## **Bath Clean Air Plan**

Bath and North East Somerset Council

### **Clean Air Zone Boundary Updates**

674726.BR.042.FBC-04 | 3

Figure 2-10: Boundary Changes Under Consideration

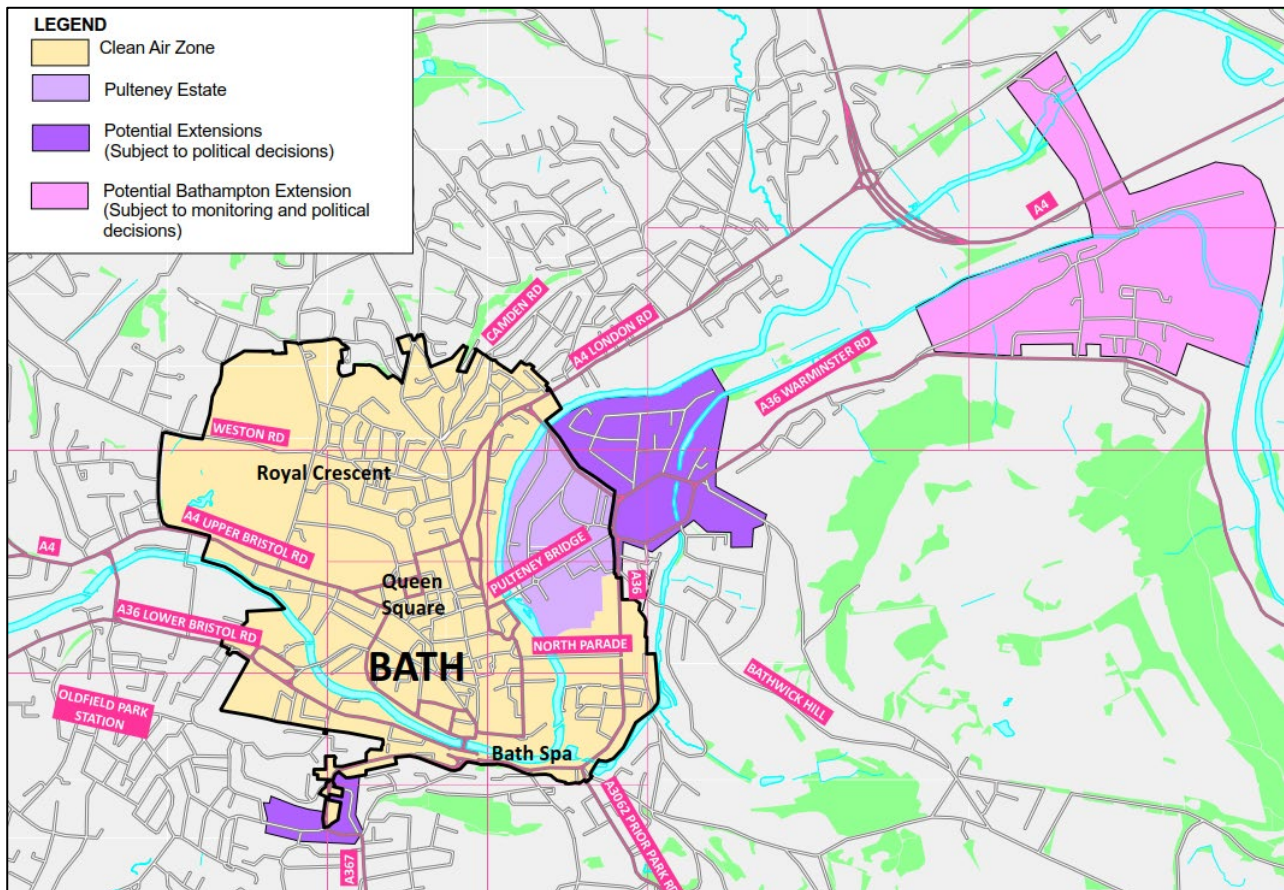
A further three proposed extensions to the CAZ boundary were presented for political decision at the final OBC sign-off and are shown in **Figure 2-10** above, highlighted in purple and pink.

The purple areas were selected for inclusion and comprise:

- To the south of the zone, further inclusion of the A367 Wells Road up to, but not including, the junction with Holloway, so including the length of the B3111 Oldfield Road up to, but not including, its junction with Junction Road.

- During the consultation period, contrasting feedback was received about moving the CAZ boundary to cover the A367 Wells Road/B3111 Oldfield Road junction. This was as follows:

- There were concerns about additional rat-running, parking, congestion and decreased air quality along both Oldfield Road and in Oldfield Park generally if the junction were to remain outside the zone and the B3111 open (noting that the northern end of the B3111 is covered by the inclusion of the A36/B3111 Brougham Hayes junction within the present CAZ boundary already).

- The Federation of Bath Residents Association (FOBRA) and the Lower Oldfield Park Residents Association and several individual respondents were in support of the inclusion of the Wells Road/Oldfield Road Junction.

- There were also requests to keep the junction excluded so it would retain non-compliant vehicle access to the doctor's surgery on Upper Oldfield Park and Hayesfield Girls School. There were

also concerns its exclusion would lead to rat running further south along Hensley Road, Egerton Road and Cotswold Road.

- Upper Oldfield Park Residents Association wanted the boundary of the CAZ here to remain in its current position, though this could have been a greater concern about it being moved north of the junction between Upper Oldfield Park and Wells Road.

2) Inclusion of the wider Bathwick area to the east of the zone, including A36 Beckford Road, A36 Warminster Road (past the junction with North Road), North Road (to the junction with Cleveland Walk), Sydney Road and Sydney Place.

- During the consultation period there were concerns from residents in the Pulteney and Bathwick Estate about an increase in idling coaches, rat-running traffic and drop-offs or parking of non-compliant vehicles in the area, as it was very close to the city centre.

- Pulteney Estate Residents Association (PERA) and Bathwick Estate Residents Association and several individual Bath residents requested that such an area, as shown by the purple, should be within the CAZ boundary.

- As shown in Section 2.7 point 1), a smaller extension covering the Pulteney Estate has now been included. This does not interfere with Sydney Gardens or Bathwick Roundabout, maintaining a suitable turning point for non-complaint HGVs reaching this part of Bath on the A36(T). However, an extension to the zone as shown could have implications in providing suitable opportunity for 'turn-back' or re-routing of non-compliant vehicles, particularly HGVs, entering Bath on the A36(T). Non-compliant vehicles would be forced to turn around using residential estate roads prior to a repositioned zone entry point on the A36 just east of the North Road junction to avoid entering the CAZ. This is potentially unsuitable for HGVs and could lead to 'entrapment' issues with non-compliant large vehicles proceeding northbound on the A36(T) beyond the B3108 Little Stoke junction to the south of Bath (Winsley).

The pink area to the east of the zone is a potential 'outlier' zone covering Bathampton. Its inclusion will be subject to traffic and air quality monitoring and should issues arise, a political decision. It is therefore not included at this time. This zone extension sitting between the A36 and London Road West would include: Bathampton Lane, Down Lane Devonshire Road, High Street, Mill Lane and all side roads with access off the roads listed. At the present time this extension is on balance not considered necessary after weighing up the following:

- Bathampton Parish Council, Batheaston Parish Council and Bathampton Primary School all requested an extension of the CAZ zone to cover Bathampton.
- During the consultation period the organisations above and many respondents expressed concern that the current boundary would lead to large amounts of traffic diverting through Bathampton and across the toll bridge. As a result, this would cause issues with increased congestion and worse air quality in Bathampton. They also highlighted a potential safety issue with additional parked cars, and a greater risk to pedestrians, especially children, in Bathampton from increased traffic.

- However, modelling has predicted that the traffic is not expected to increase excessively across the toll bridge, the route is already heavily constrained by the capacity available in peak hours and this is well known by local drivers.

- Further to this there is no case to include this area to achieve air quality compliance by 2021.
- There are also concerns that including this area would leave no convenient crossing point over the River Avon to the east side of the city for non-compliant drivers, with the B3108 at Winsley offering the nearest viable alternative, well to the south of Bath.

As such it was proposed to introduce a programme of regular monitoring to establish changing traffic flows and potentially journey times on the Bathampton Lane/Mill Lane/Toll Bridge Road route in the pre-CAZ and post-CAZ scenarios. Comparison of 2014 and 2018 flows on Toll Bridge Road has shown no appreciable change in two-way 'peak' weekday flows at the Toll Bridge, but a perceivable growth change in the average inter-peak hour flow over the period 2014-2018. Further data collection up to CAZ implementation will enable what appears to be an underlying growth trend to be established. In the post-CAZ scenario, this can then be accounted for in establishing any true 'extra-over' effects of the CAZ. If the outcome from future comparison

analyses does reveal a net impact of significance, then a decision could be taken then to introduce an 'outlier' CAZ if required, subject to a full public consultation. As the route is already subject to a 4-ton weight restriction and has traffic calming and a 20mph speed restriction in parts, it is considered that little could be achieved using further formal traffic management measures to deter vehicle usage. Increasing charges on the Toll Bridge is also outside of the control of B&NES.

Figure 2-11: Eighth Proposed Amendments to the CAZ

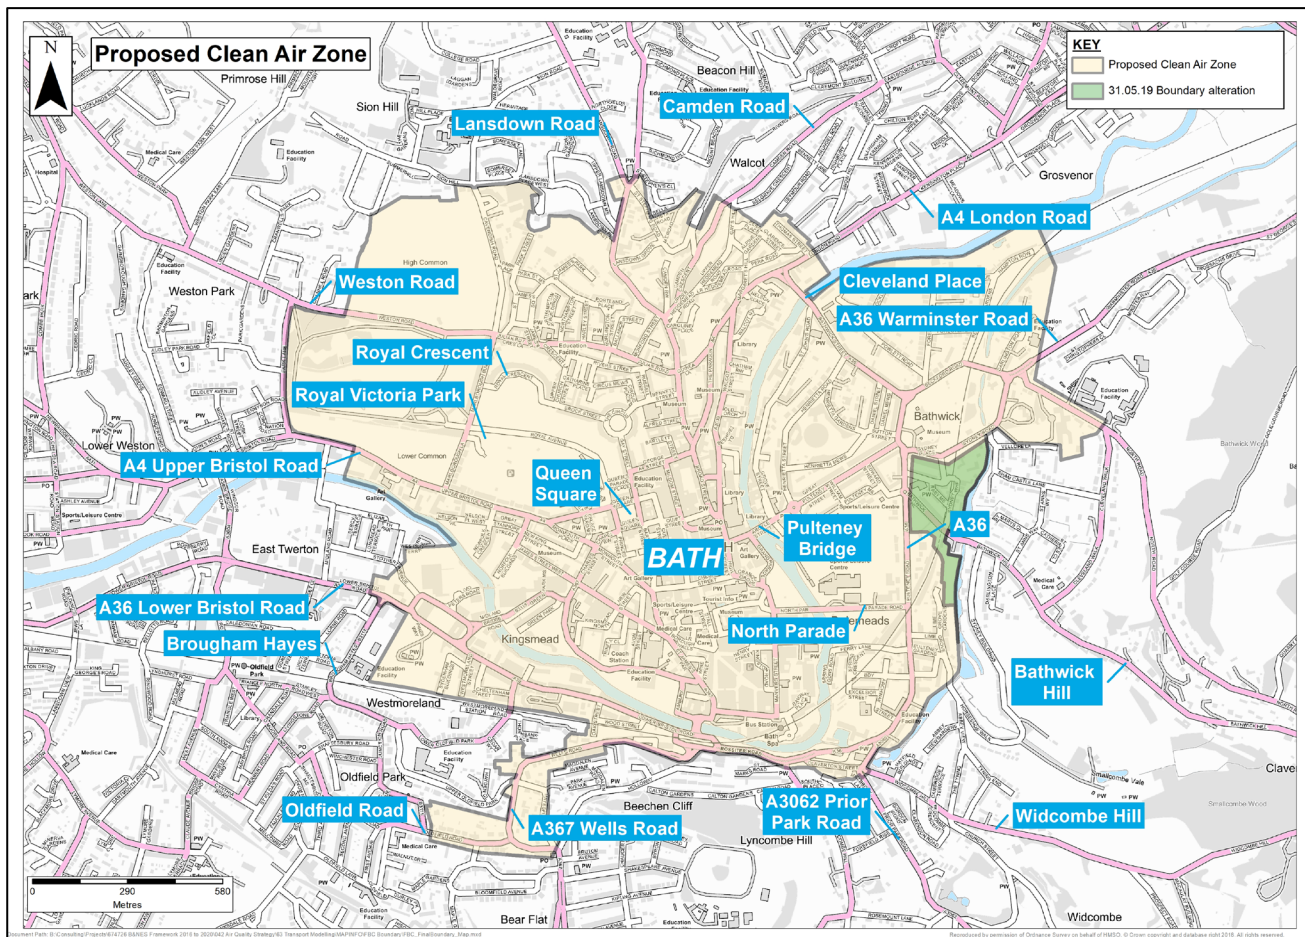
A further minor change is proposed to the boundary for practical reasons. The area adjusted is highlighted by the green shading in

Figure 2-11. The boundary as it stood before would require four camera locations, at; Sydney Mews, Raby Mews, Sydney Wharf and Sham Castle Lane. This would require 7 ANPR cameras and 16 signs to monitor a very predominantly residential area.

As is shown, extending the boundary to the canal from Sydney Road to Bathwick Hill will define the zone more clearly and reduce the infrastructure requirements to 3 ANPR cameras and 8 signs. Further advantages of revising the boundary are:

- It makes technical installation easier to achieve (power/communications/installing posts);
- Reduces negative impact on streetscape;
- Aligns to include all of the associated Residents Parking Zone;
- Doesn't discriminate between different areas of Bathwick i.e. some properties in and some out of zone; and

- Leaves potential to redeploy cameras elsewhere or reduce/reallocate budget.

Figure 2-12: Ninth Proposed Amendments to the CAZ

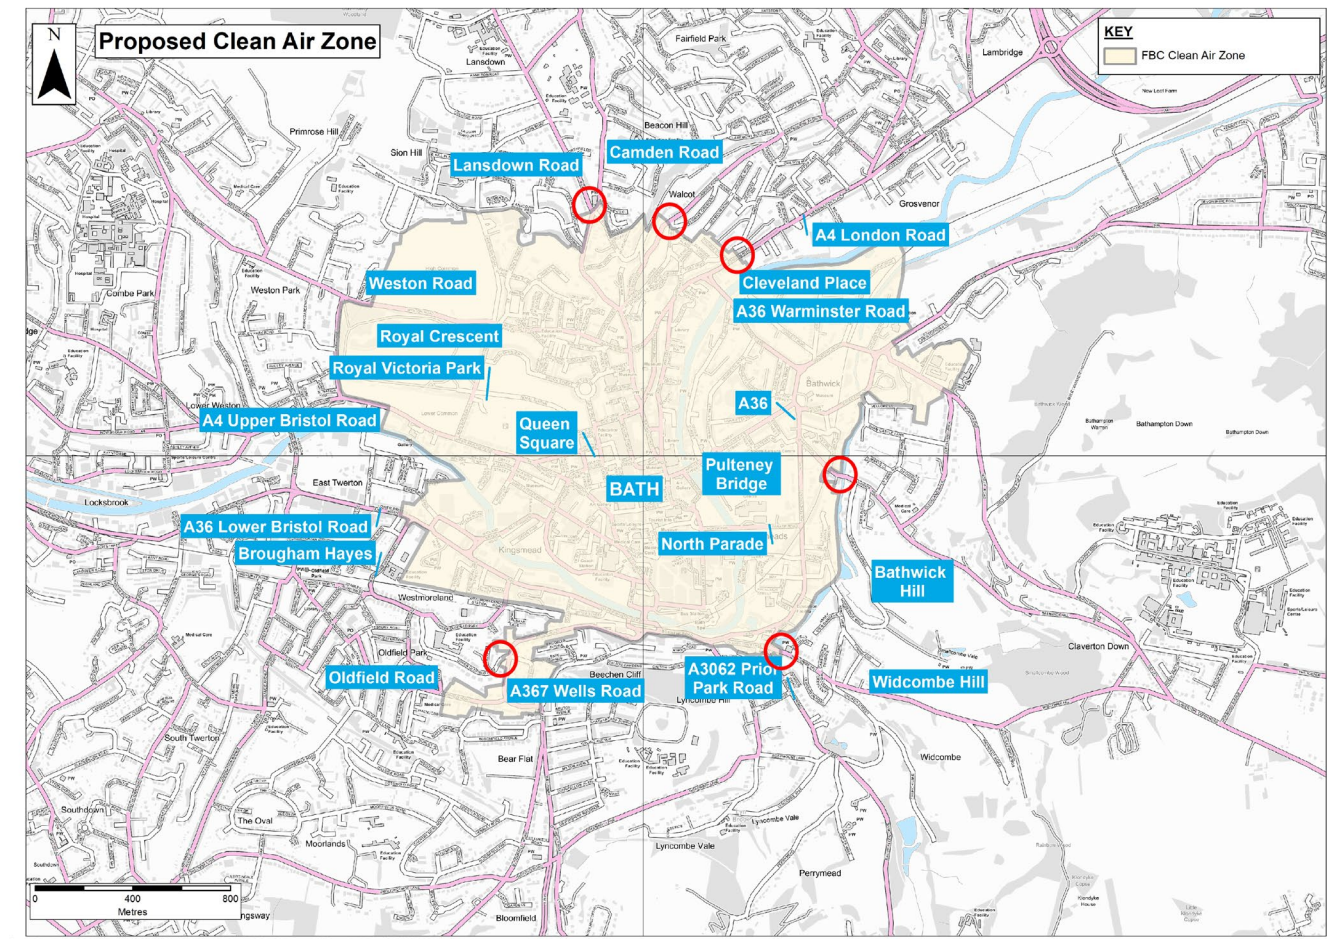
Recent changes were made to Bath's proposed Clean Air Zone (CAZ) boundary as part of the detailed design development for the scheme, circled in Figure 2-12. The changes are minor and do not affect the impact or rationale of the scheme in any way but involve a small number of buildings which are located around the perimeter edge of the proposed zone. These proposed amendments have been made due to on site surveys and stipulations made by equipment suppliers on site which will ensure effective installation and operation of infrastructure moving forward.
